Amendment Report for the Application of a Substantive
Amendment to the Environmental Authorisation issued
for the development of the 140 MW Sutherland 2 Wind
Energy Facility, Sutherland, Northern Cape Province

FINAL AMENDMENT REPORT

DEA Ref Number:
12/12/20/1782/3/AM3

November 2019

Figure 1: Locality map illustrating the authorised turbines and relocated turbines

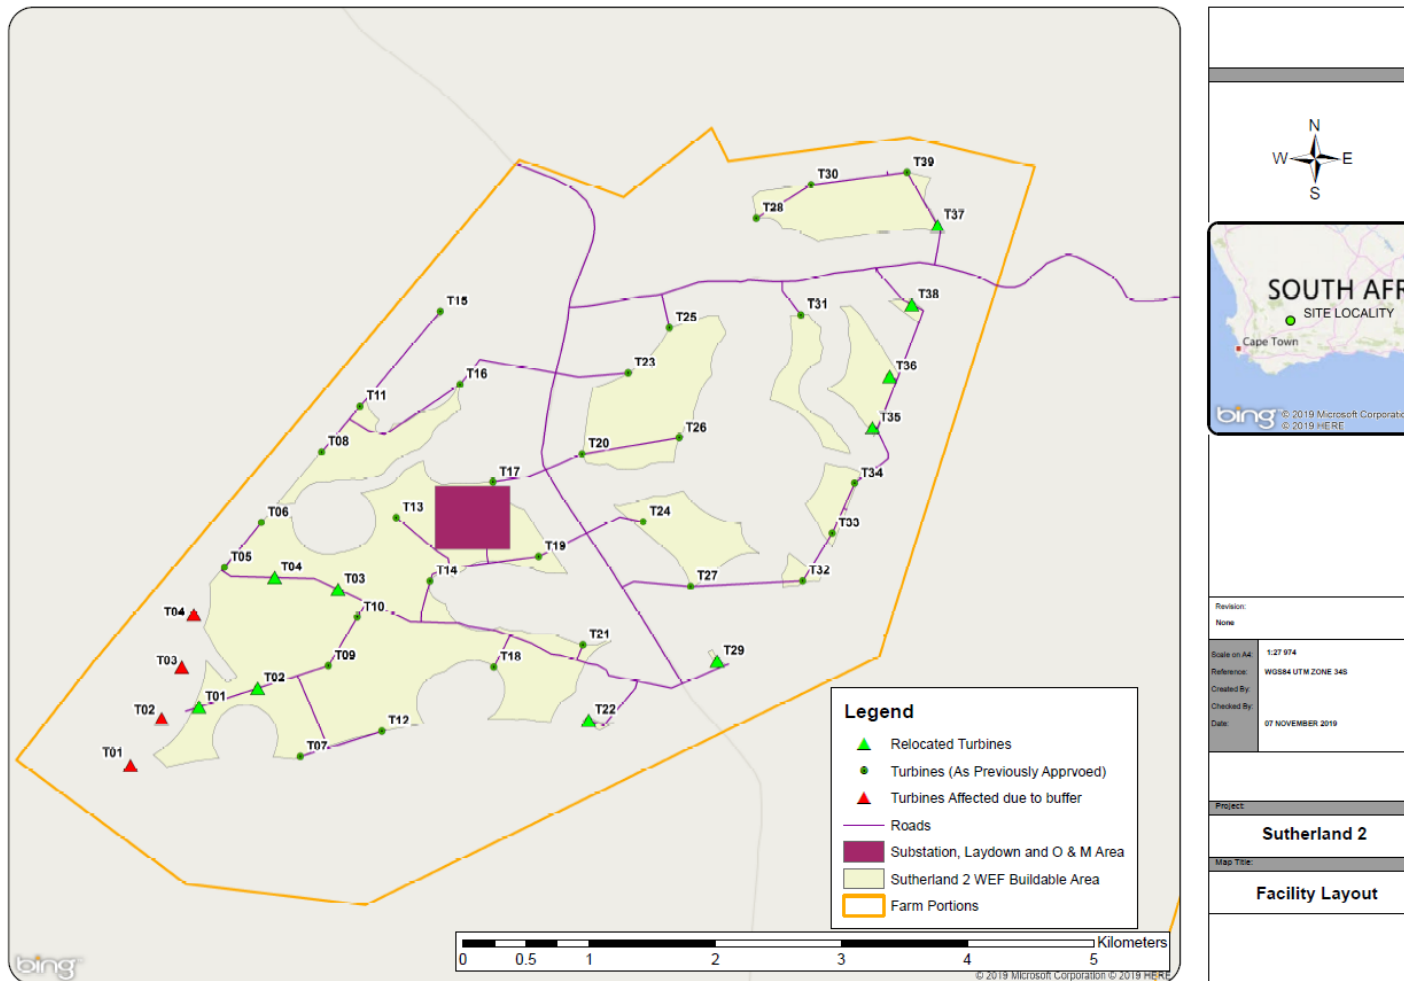
It should be noted that although the number of turbines has decreased, the turbine layout remains the same. In addition, four turbines (T01 – T04) have been relocated within the approved buildable area to accommodate environmentally sensitive areas.

Figure 5: Changes in specifications of turbine dimension

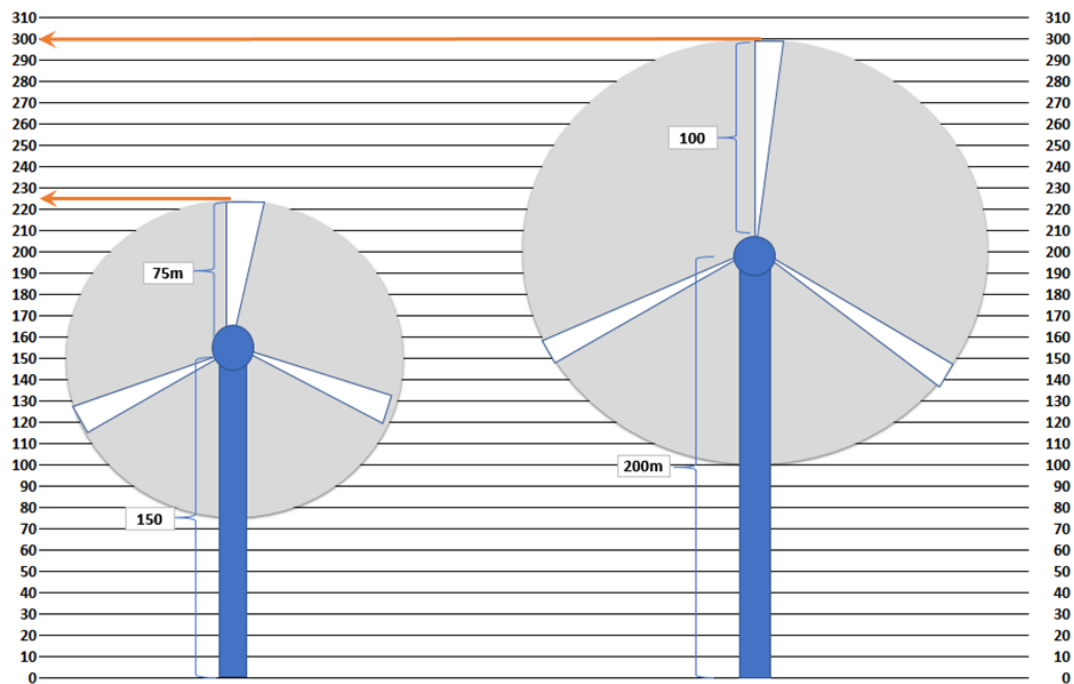
The main negative impact of turbines on bats is the encroachment of air space where bats forage or commute. Table 7 and **Figure 5** indicate the increase in the volume of the total swept area, if turbine sweep is calculated as a sphere. For example, should 39 turbines be installed, with a hub height of 200 m and a rotor diameter of 200 m, there will be a 96.69 % increase in swept area. The lowest point of the sweep of the turbine blades is also indicated, as this could have an impact on bat mortality (see Literature review in Section 4.1 of the Bat specialist report (Moir & Dippenaar, 2019, included in Appendix C of this report).

Figure 10: Combined viewshed of the Rietrug, Sutherland and Sutherland 2 wind energy facilities viewshed: Difference: 150-200 m Hub Height (Oberholzer and Lawson, 2019)

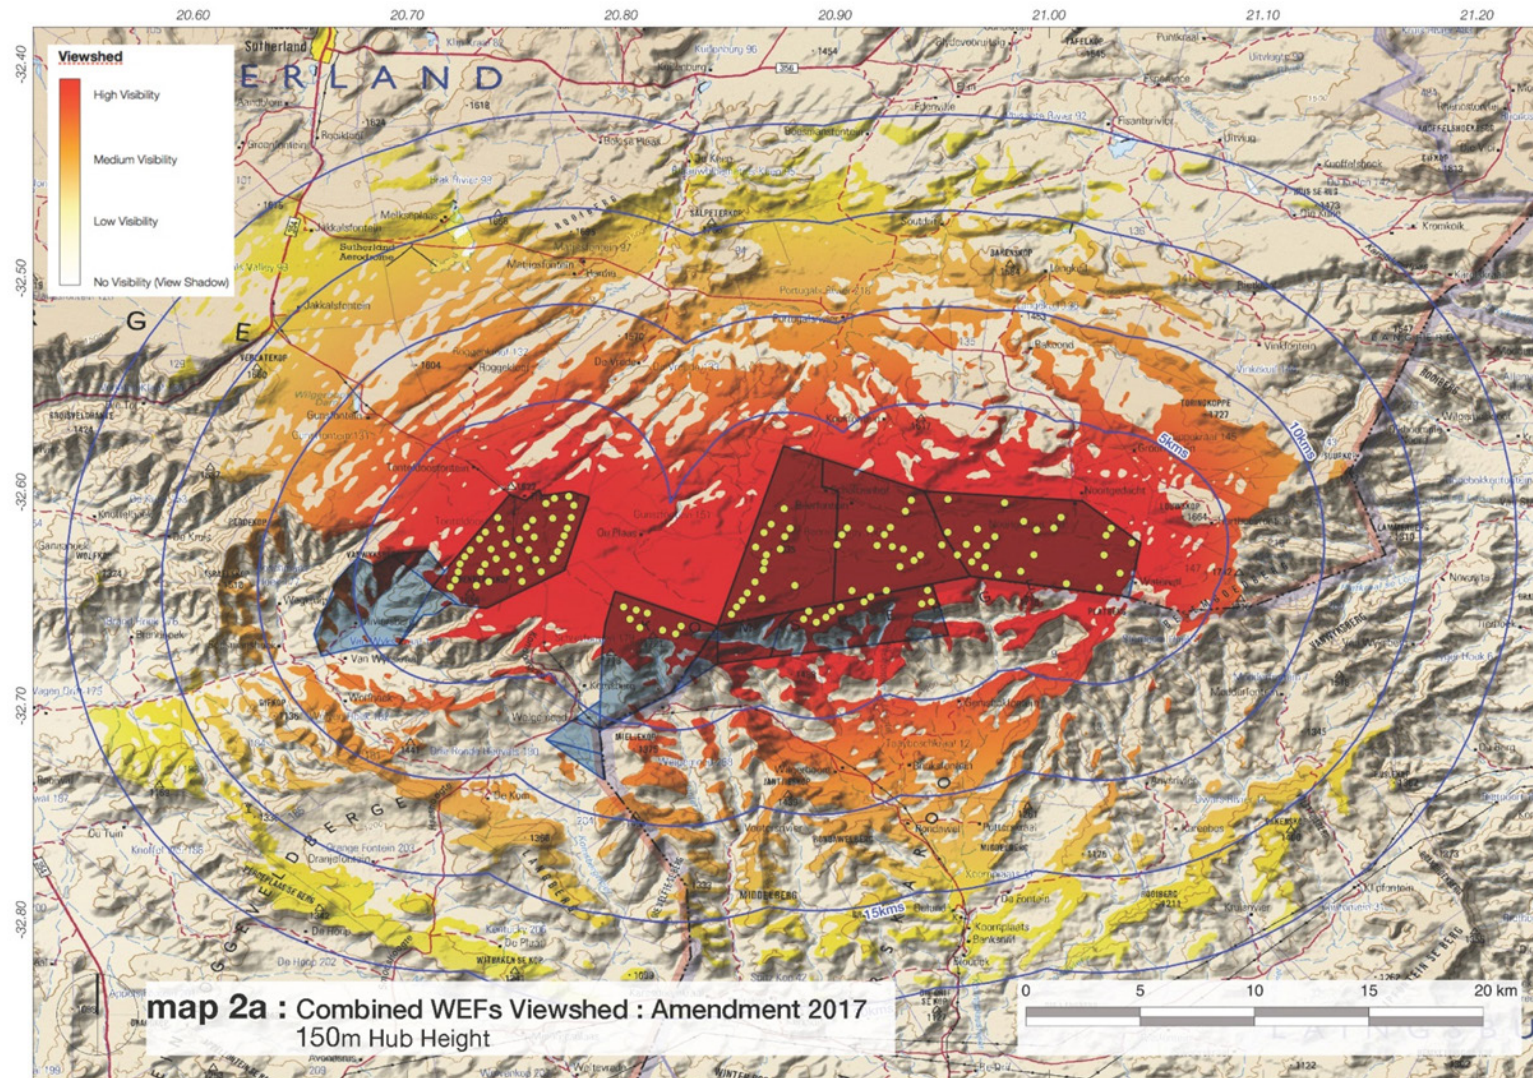
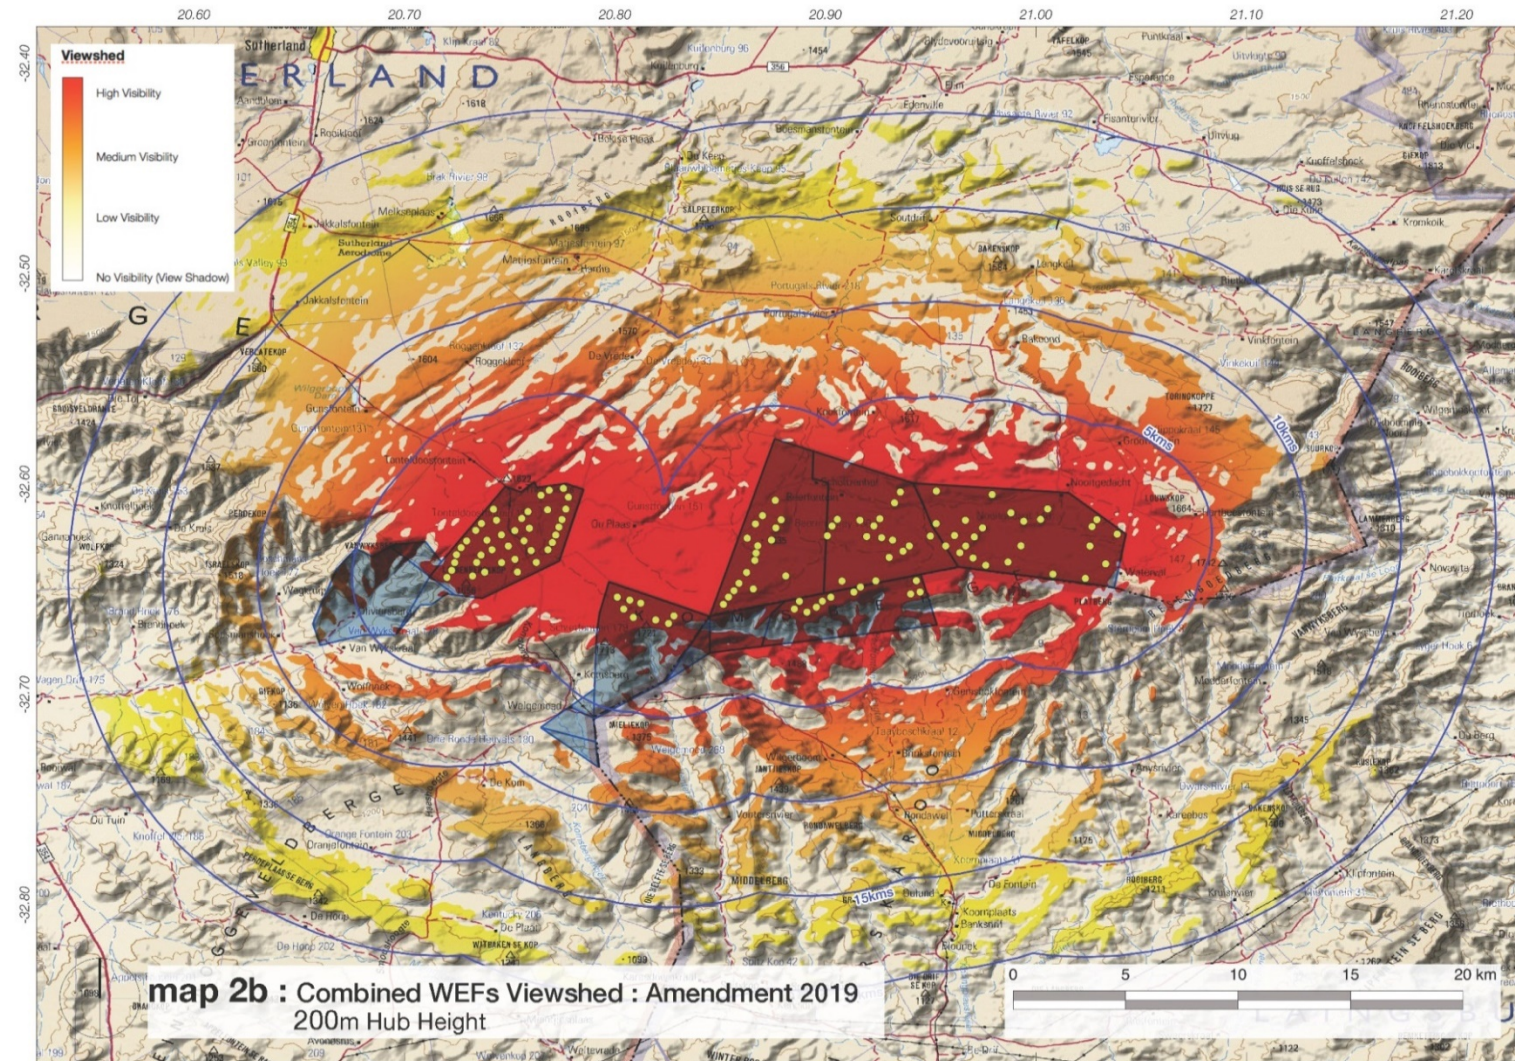
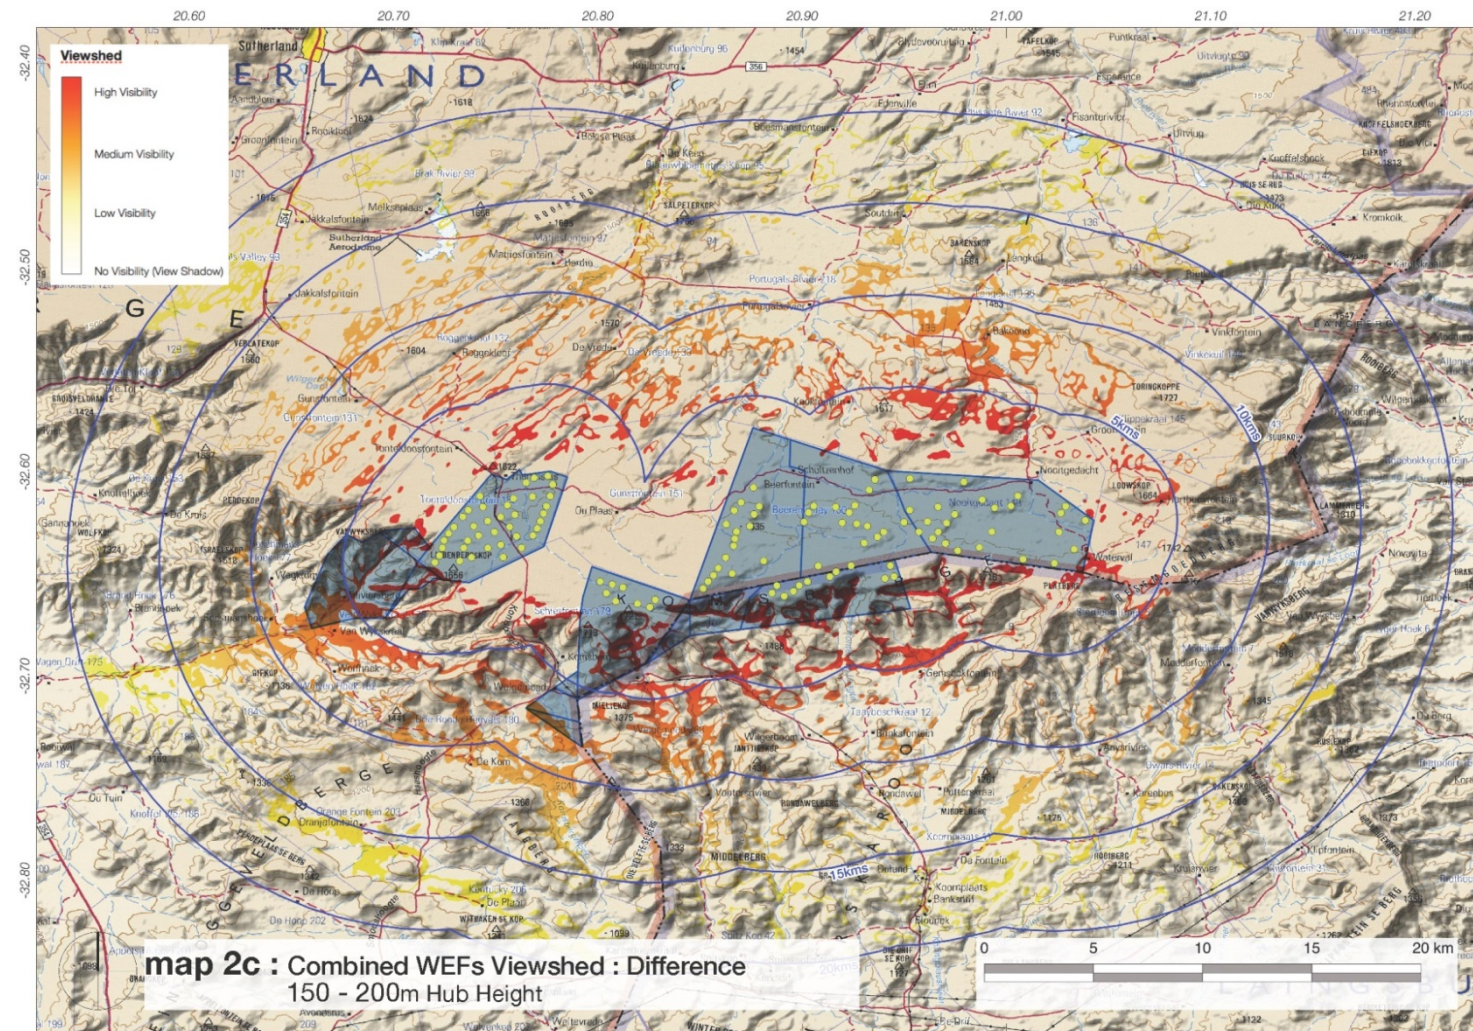
A comparison of the combined viewsheds of the 3 proposed wind farms for the Amendment 2 layout and the current layout is illustrated in Figure 8 and Figure 9. The difference in visual exposure between these two is shown in Figure 10. Again, the cumulative difference in visual exposure is fairly minimal, but the visual effect on the Komsberg escarpment scenic resource would increase. The cumulative visual effect could be partly offset by increasing the visual buffer from the edge of the escarpment to 660 m.

Figure 11: Authorised layout and amended layout of the proposed Sutherland 2 Wind Energy Facility

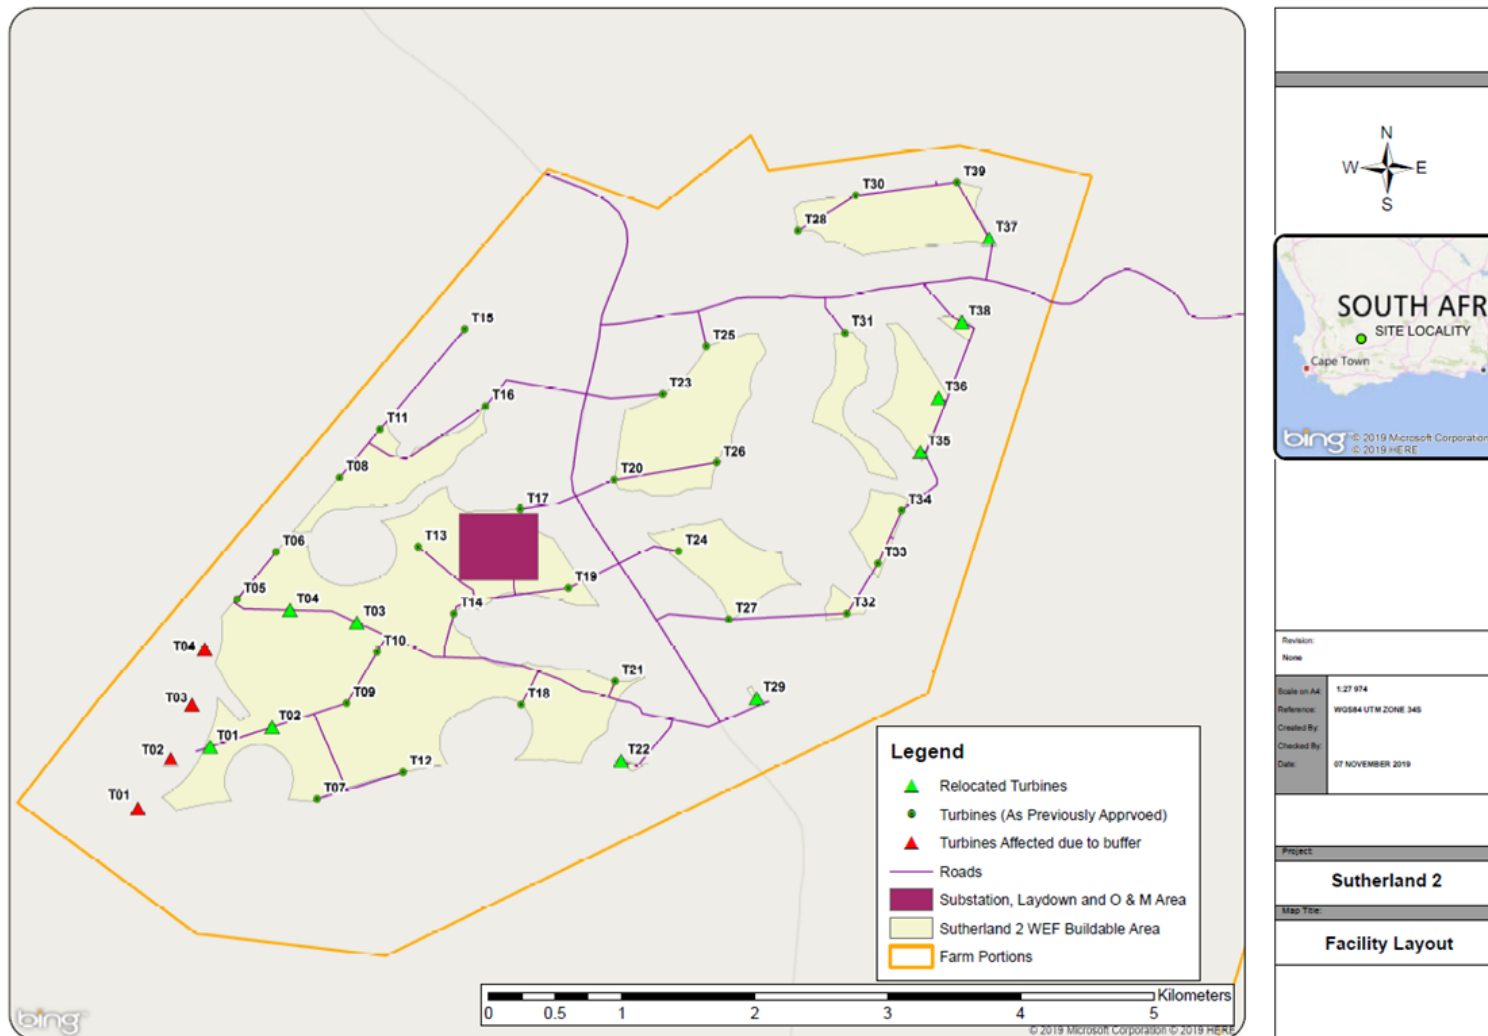
The proposed amendments are deemed substantive i.e. a change in scope occurred resulting in increased level or nature of impact. **The larger turbine specifications have reduced the number of wind turbines required from 47 to 39. It should be noted that although the number of turbines has decreased, the turbine layout remains the same. Furthermore, it should be noted that four turbines (T01 – T04) have been relocated within the approved buildable area to accommodate environmentally sensitive areas** (Figure 1). The proposed amendments are deemed substantive as per Regulation 31 (Part 2) of the 2014 NEMA EIA Regulations, as amended, i.e. a change in scope occurred resulting in increased level or nature of impact.
